ITS CORPORATION			REV	ECN	DATE	APV
THIS PRINT IS THE PROPERTY OF ITS CORP. IT SHALL NOT BE COPIED WITHOUT PERMISSION.			TITLE			
			SCHMEMATIC, AMP./ATTENUATOR MODULE MMDS (1132-1509)			
MATERIAL			DWN	JCM	11/21/91	DWG. NO.
FINISH			CHK	JCM	11/14/91	1132-3509
			REL	JCM	11/14/91	REV
			SCALE ---		SHEET 1 OF 1

ITS CORPORATION				REV	ECN	DATE	APV
REV	ECN	DATE	APV	THIS PRINT IS THE PROPERTY OF ITS CORP. IT SHALL NOT BE COPIED WITHOUT PERMISSION.			
				MATERIAL			
				FINISH			
TITLE				SCHEMATIC – BROAD BAND CAVITY FILTER, 3 SECTION (1107–1101)			
DWN		JEO	6/27/88	DWG. NO.		REV	
CHK		RE	6/29/88	1107–3101		0	
REL		RE	6/29/88	A	SCALE ---	SHEET 1 OF 1

ITS CORPORATION				REV	ECN	DATE	APV
THIS PRINT IS THE PROPERTY OF ITS CORP. IT SHALL NOT BE COPIED WITHOUT PERMISSION.				TITLE SCHEMATIC - TRANSMITTER CONTROL BD. (1510-1104)			
				DWN	KEF	3-28-94	DWG. NO.
MATERIAL				CHK	CAR	5/10/94	1510-3104
FINISH				REL	KEF	11/17/94	2
				SCALE ---		SHEET 1 OF 1

ITS CORPORATION					REV	ECN	DATE	APV
THIS PRINT IS THE PROPERTY OF ITS CORP. IT SHALL NOT BE COPIED WITHOUT PERMISSION.					TITLE			
					SCH. BIAS PROTECTION BD. 4 SECTION (1500-3114)			
MATERIAL					DWG. NO.			
FINISH					1500-3114			
---					5			
---					1 OF 1

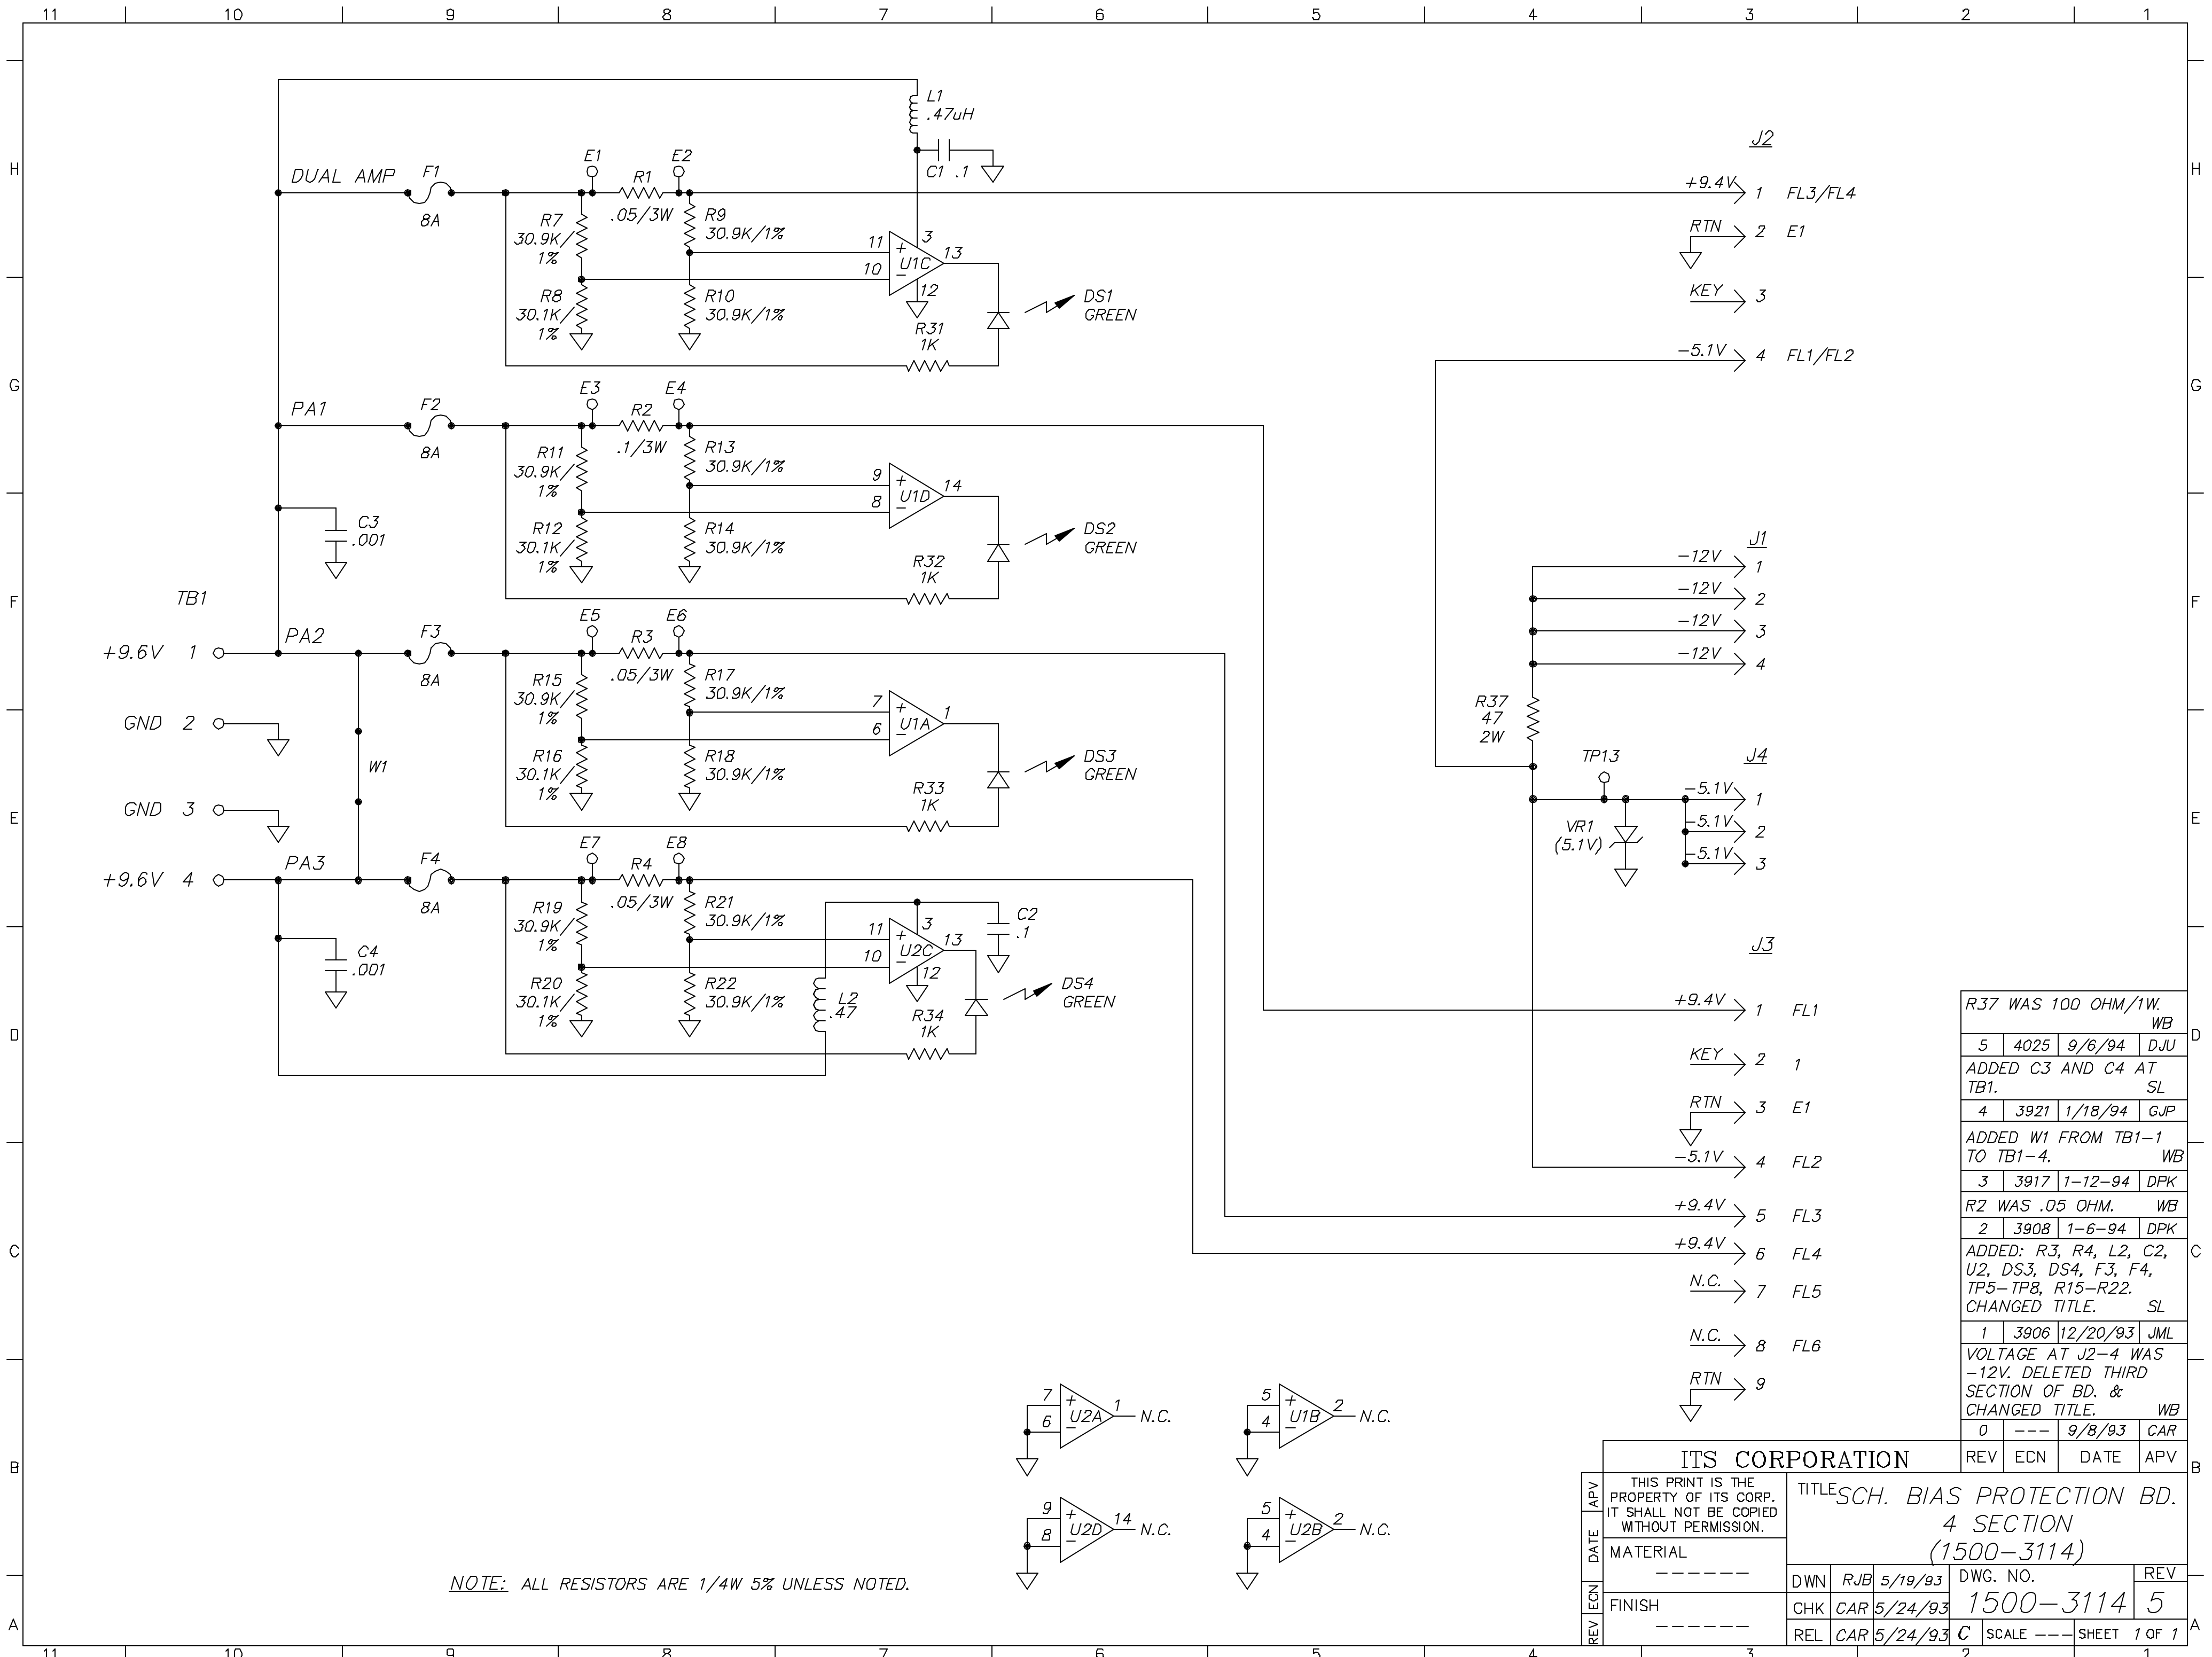
R37 WAS 100 OHM/1W.				WB
5	4025	9/6/94	DJU	
ADDED C3 AND C4 AT TB1.				SL
4	3921	1/18/94	GJP	
ADDED W1 FROM TB1-1 TO TB1-4.				WB
3	3917	1-12-94	DPK	
R2 WAS .05 OHM.				WB
2	3908	1-6-94	DPK	
ADDED: R3, R4, L2, C2, U2, DS3, DS4, F3, F4, TP5-TP8, R15-R22.				SL
CHANGED TITLE.				
1	3906	12/20/93	JML	
VOLTAGE AT J2-4 WAS -12V. DELETED THIRD SECTION OF BD. & CHANGED TITLE.				WB
0	---	9/8/93	CAR

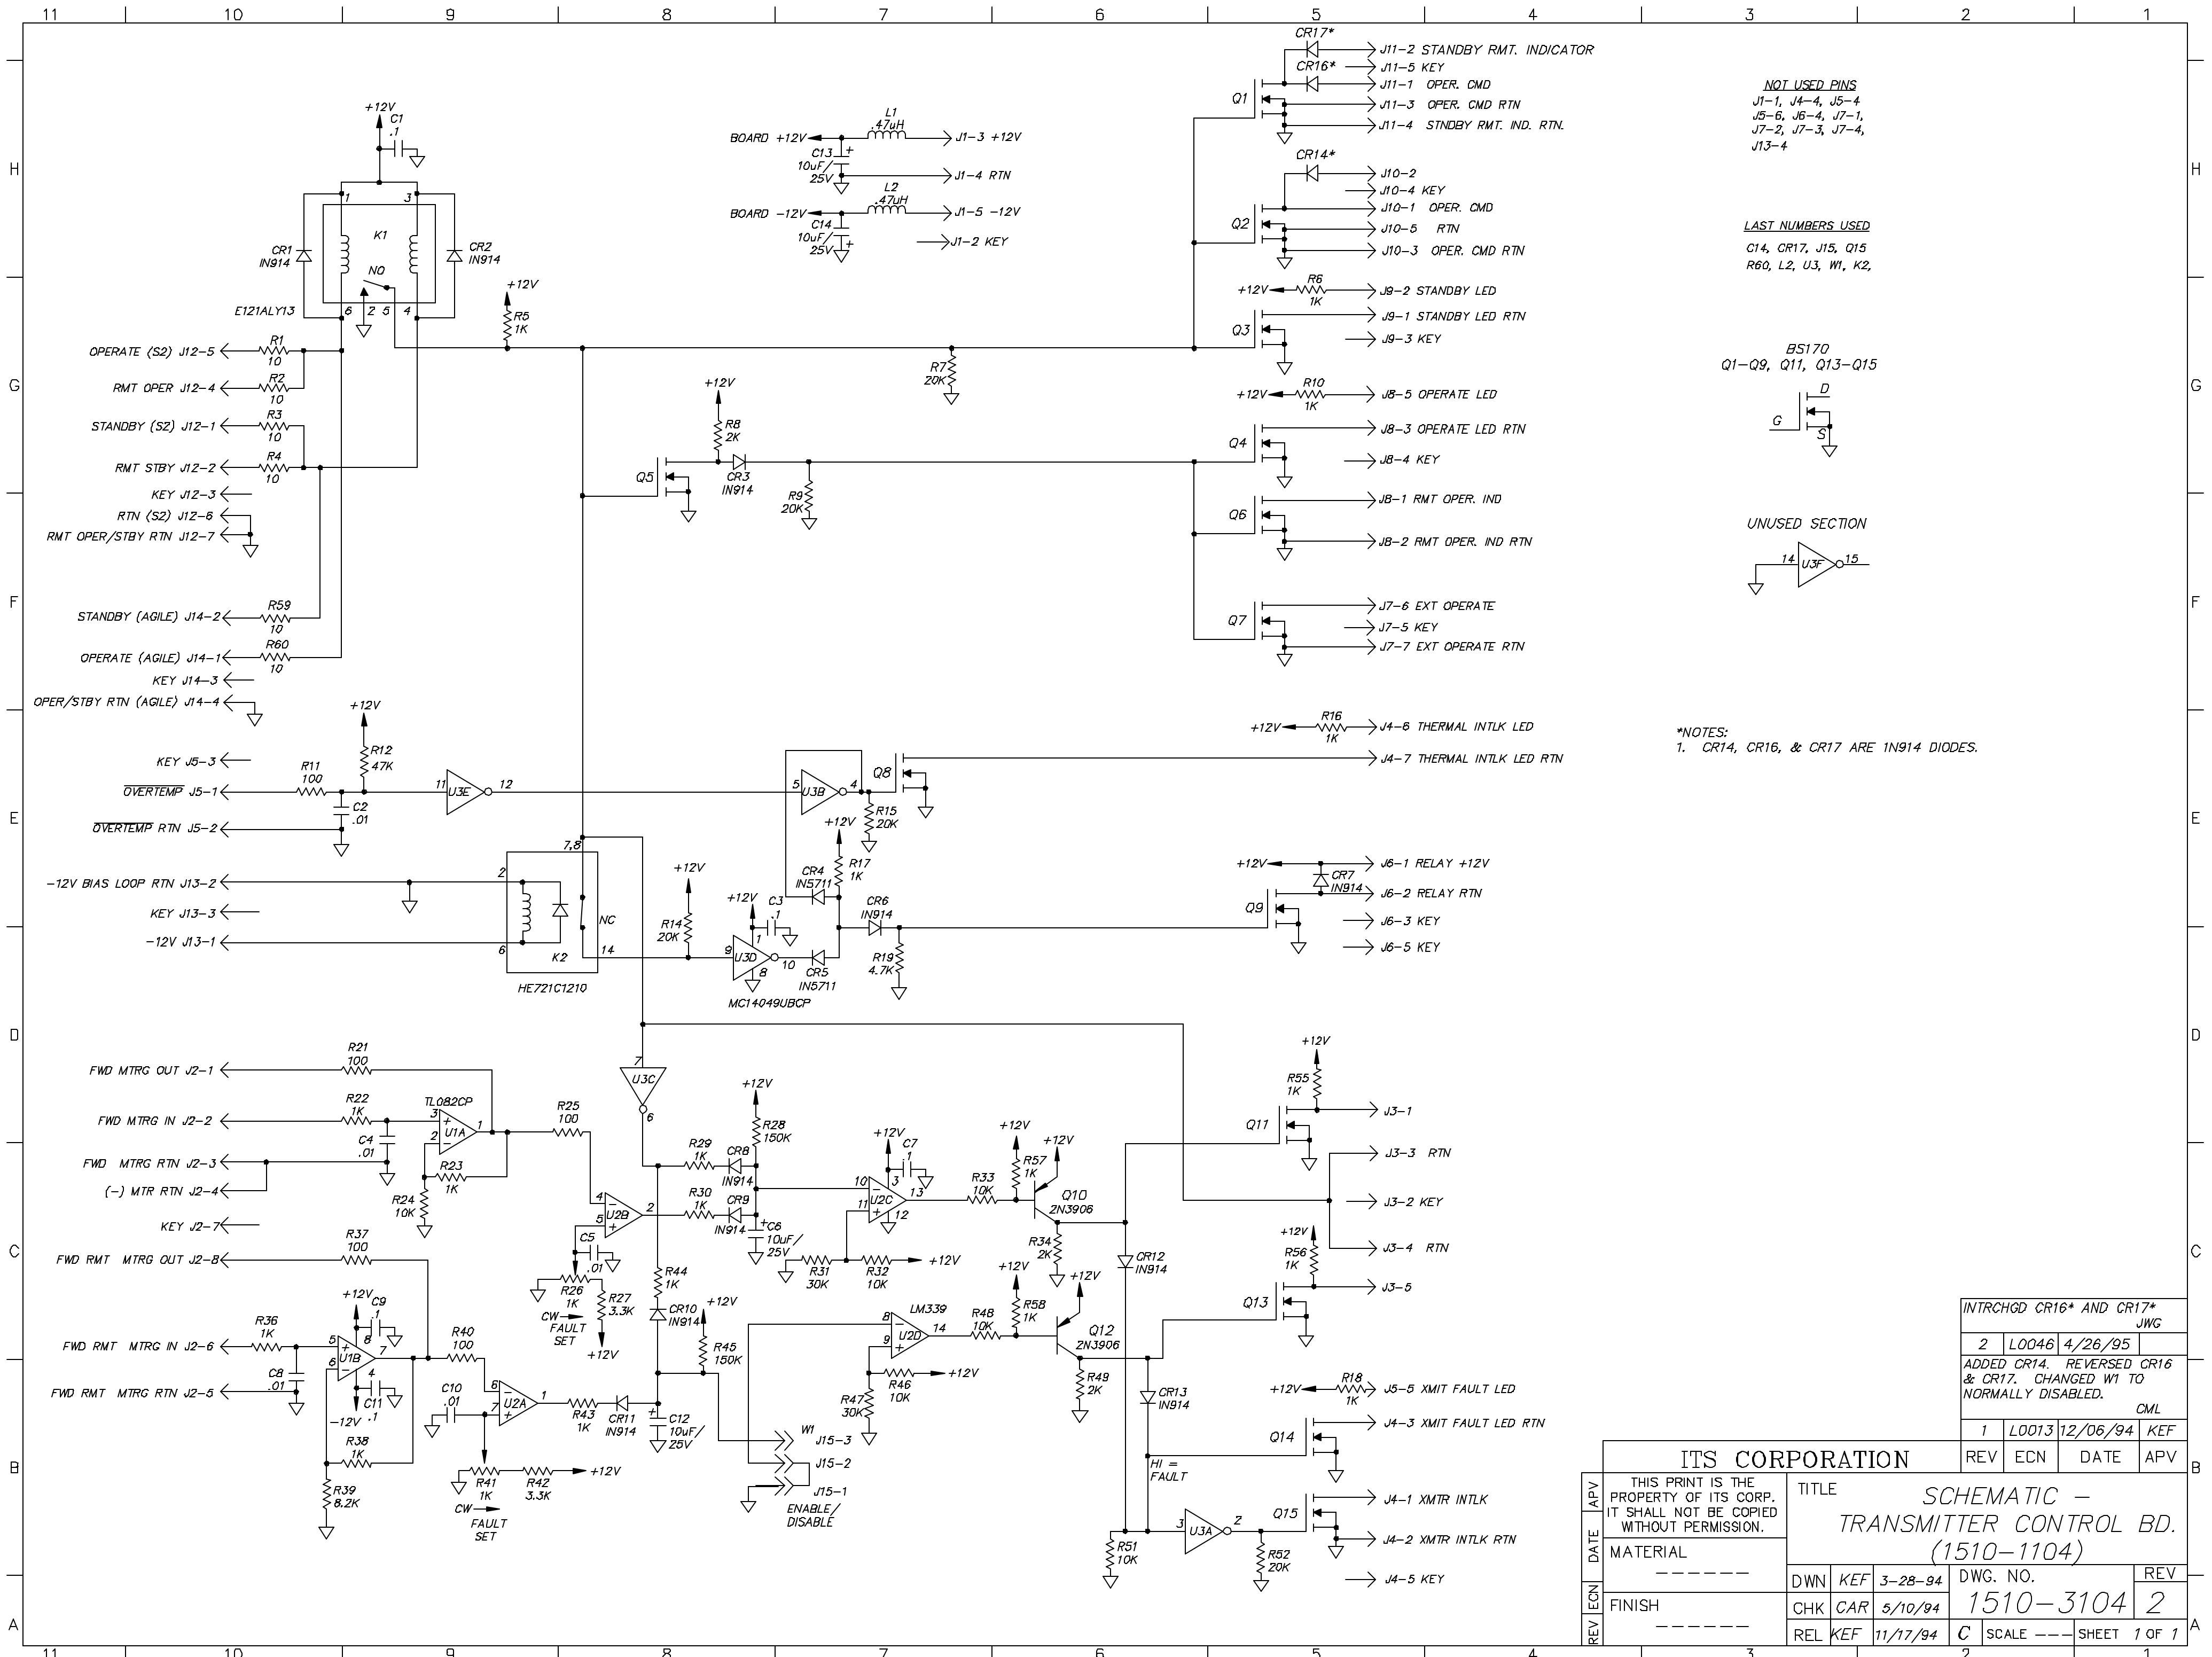
INTRCHGD CR16* AND CR17* JWG			
2	L0046	4/26/95	
ADDED CR14. REVERSED CR16 & CR17. CHANGED W1 TO NORMALLY DISABLED.			
1	L0013	12/06/94	KEF
